9 BROWN STREET, PORTARLINGTON

Acoustic Report for Endorsement

DOC. REF: V2202-01-P ACOUSTIC REPORT (R1)
1 MAY 2026

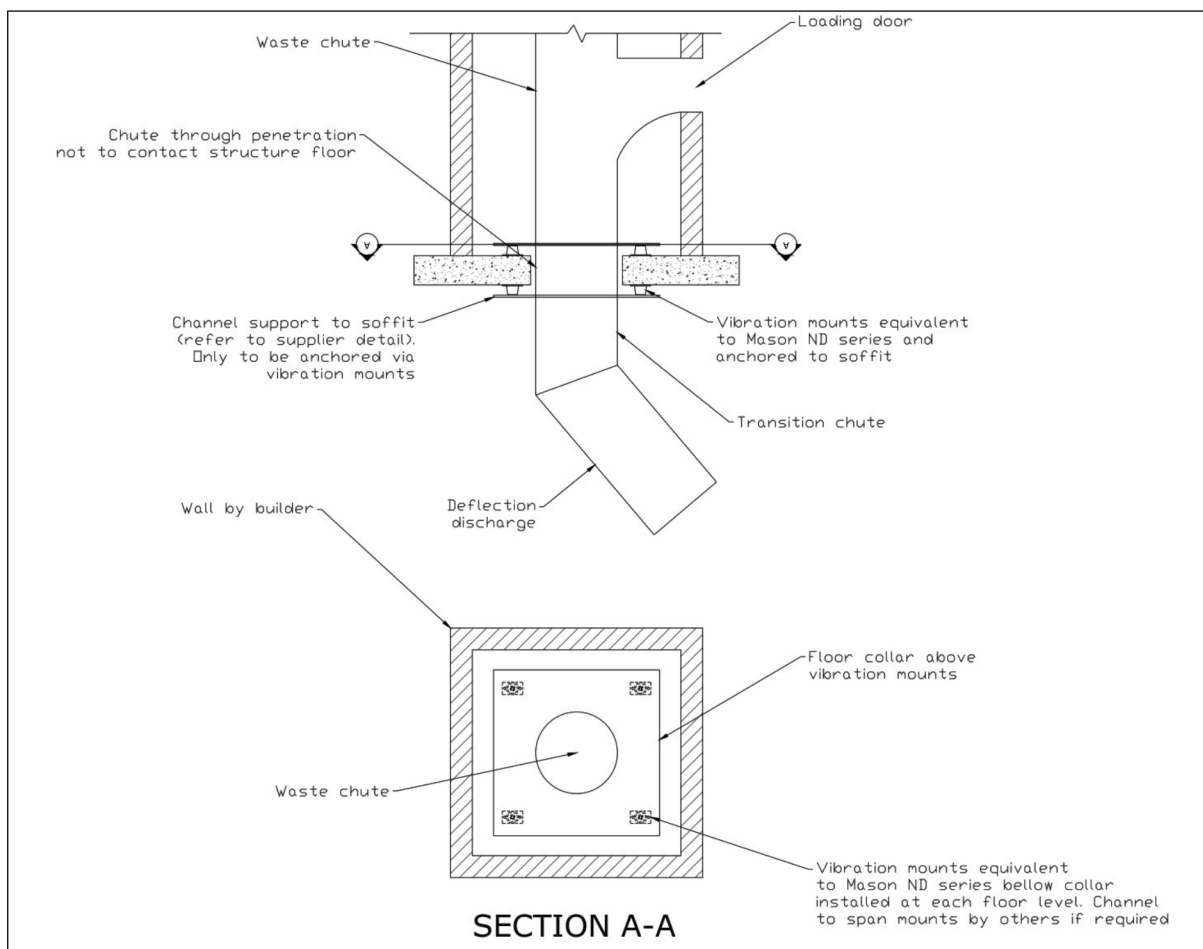
An example of an isolated typical bin chute detail is shown below:

- Steel chutes can be acoustically lagged with Pyrotek Soundlag or equivalent. Plastic chutes do not require lagging.
- Slab connections can be installed on rubber outriggers, equivalent to Mason ND mounts
- Avoiding chute anchoring to walls (e.g. only anchored on slab level)
- Where chutes require a deflector at the bottom, it could be isolated via ND mounts, or equivalent (e.g. not anchored directly to soffit)
